Topic	Mulsanne side view camera control module (SC12/15)
Market area	Worldwide Bentley (1WBE)
Brand	Bentley
Transaction No.	2030874/3
Campaign number	E775
Note	E775
Type	
US code

### Mulsanne

Figure 1

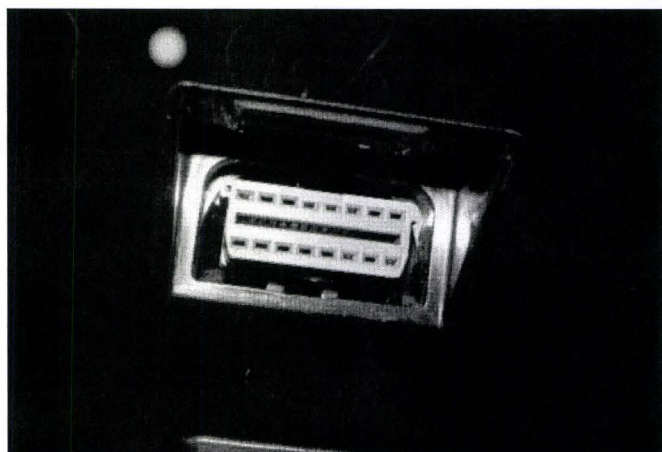
In January 2012 a TPI was released which instructed Dealers to remove where fitted the side view camera control module as a potential fault was identified with the original part. The latest specification side view camera control module is now available for all Bentley Mulsanne vehicles which were specified with the side view camera option. If the original module has been previously removed and replaced with the link loom as per previous instruction, a Yellow paint mark will be evident on the diagnostic plug surrounding cover as shown in Figure 1, please remove the loom and fit the replacement side view camera module as detailed within this document.

Should the vehicle still have the original side view camera module fitted or the link loom was installed at the time of production a Yellow paint mark will not be evident, if this is the case please replace the existing module or remove the link loom and replace with the latest specification part as detailed within this document.

Figure 1

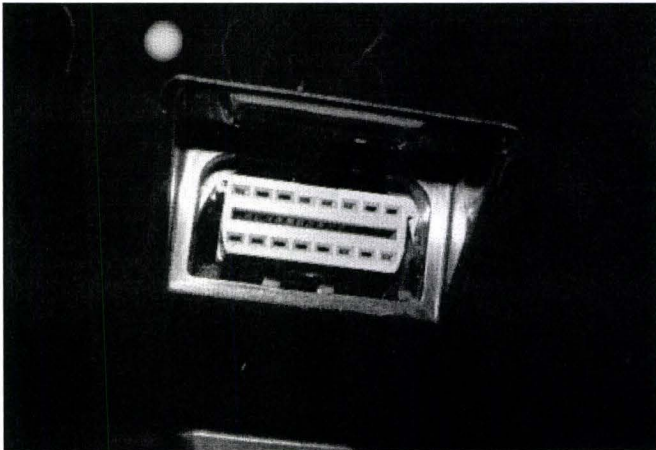
In January 2012 a TPI was released which instructed Dealers to remove where fitted the side view camera control module as a potential fault was identified with the original part. The latest specification side view camera control module is now available for all Bentley Mulsanne vehicles which were specified with the side view camera option. If the original module has been previously removed and replaced with the link loom as per previous instruction, a Yellow paint mark will be evident on the diagnostic plug surrounding cover as shown in Figure 1, please remove the loom and fit the replacement side view camera module as detailed within this document.

Should the vehicle still have the original side view camera module fitted or the link loom was installed at the time of production a Yellow paint mark will not be evident, if this is the case please replace the existing module or remove the link loom and replace with the latest specification part as detailed within this document.

3. Should the original side view camera control module have been previously removed and replaced with the link loom 3Y0 998 381 there should be a Yellow completion paint mark on the diagnostic plug surrounding cover (Figure 1), please carefully remove this and replace with a White paint completion mark as shown in Figure 2. If the original control module has been replaced for the latest specification part or the factory fitted loom has been replaced with the latest specification part, a White paint completion mark should also be added (Figure 2)

Figure 2

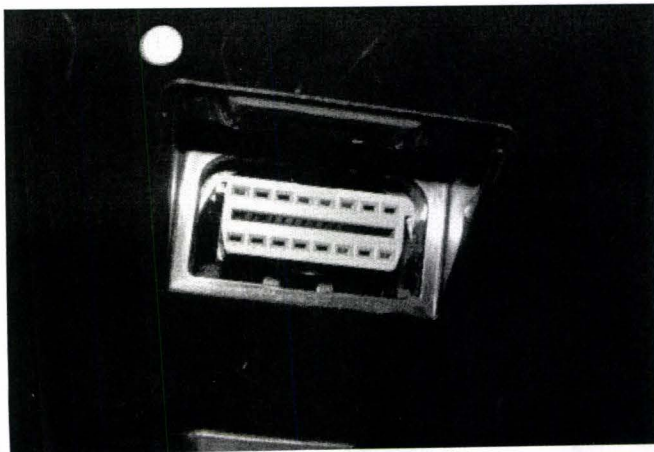
If the vehicle is not already listed as repaired in "Repair history" (in Elsa pro), check for the Campaign completion identification mark which is a White paint mark located above the diagnostic plug cover (Figure 2) the White mark confirms the latest specification part has been fitted, should neither be evident carry out the required work in accordance with instructions.

White paint mark on the diagnostic plug surrounding cover confirms the latest specification part has been fitted.
